**Exhibition of State Significant Infrastructure Application
INLAND RAIL – ILLABO to STOCKINBINGAL
Application number SSI-9406**

Junee Shire Council (JSC) welcomes the opportunity to make a submission in relation to Inland Rail's (IR) Illabo to Stockinbingal (I2S) Environmental Impact Statement (EIS).

Summary of Feedback

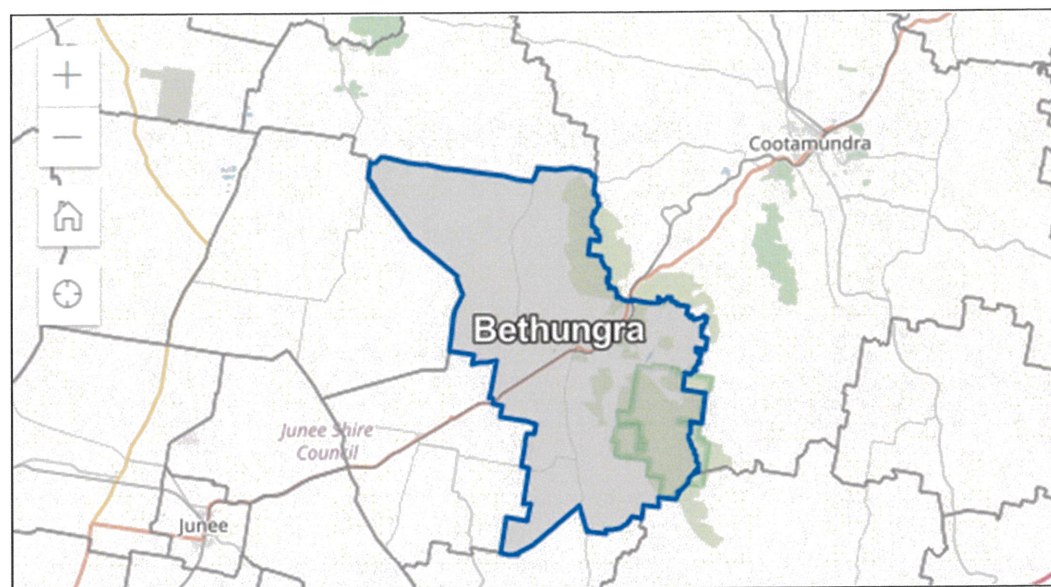
Junee Shire Council assessment	I2S EIS response	Junee Shire Council comments on EIS
Ch4.3.2 Ch7.3.2	Crossing Loop and Rail Maintenance Access Road	Acknowledged	JSC thank the proponent for changing the location of the rail maintenance access road to the eastern side of the rail corridor to improve firefighting outcomes.
Ch5.5 -	Table 5-1 Strategic Context	To be addressed.	<p>The EIS refers to the Future Transport Strategy 2056, but the proponent has not considered the broader aspects of this strategy – assessment is confined to the benefits of the Inland Rail and direct impacts on the rail corridor only.</p> <p>Recommendation: The proponent addresses the Future Transport Strategy 2056 with a more integrated approach with other modes, considering the broader aspects of this Strategy.</p>
Ch7.2.7.2	Private Crossings and Cumulative Agricultural Impact	To be addressed.	<p>The EIS identifies the proposal would interface with 75 private roads including six primary access tracks and 58 existing farm tracks. The EIS states that:</p> <p><i>Where occupational (private) crossings are proposed, ARTC would work with landowners to develop a design that takes into account their requirements. For example, in areas where landowners use large farm machinery and run livestock, the design of the level crossing would include stock-proof fencing, secured gates and suitable approach grades.</i></p> <p>JSC holds concerns regarding the cumulative impacts on agriculture efficiency that may negatively affect the agricultural sector given the extent of the I2S project.</p> <p>Recommendation In addition to the proponent negotiating with individual landowners for on-farm private crossings and stock underpasses, the proponent should also undertake analysis on the cumulative economic impacts of the I2S project on the agriculture sector including economic impacts of reduced accessibility of or to agricultural land.</p>
